## **T8 P0EA773 Auxiliary Cooling System Performance**

REF NO:	ISSUING DEPARTMENT:	CAR MARKET:		
TJ 34123.1.6	Technical Service	United States and Canada		
3 US 7	PARTNER:	ISSUE DATE: 2019-02-12	STATUS DATE: 2019-02-18	
	010101000	2019-02-12	2019-02-10	
FUNC GROUP:	FUNC DESC:			
2647	Heater, thermostat	Page	1 of 4

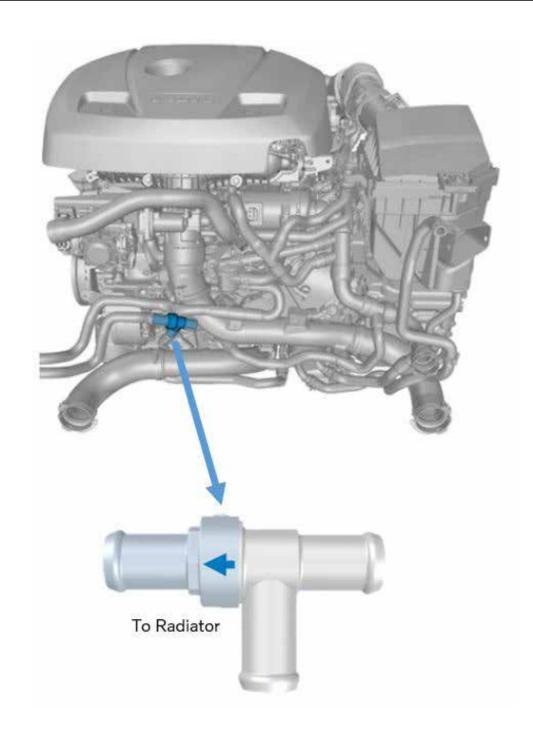
A new component is now available for replacement and the old thermostat part number has been blocked. Do not install old component.

Please order and install component 32139082. In the coming weeks, this may be superceded by 32263957 & 32263958. These components are identical in function.

Before installing component, please verify that the correct component is installed. The new components can be recognized by the orifice visible from one side. See attached photo as example.

Note: Orientation of the component is critical to correct operation. See attached photo US34123\_ Orientation Illustration.jpg
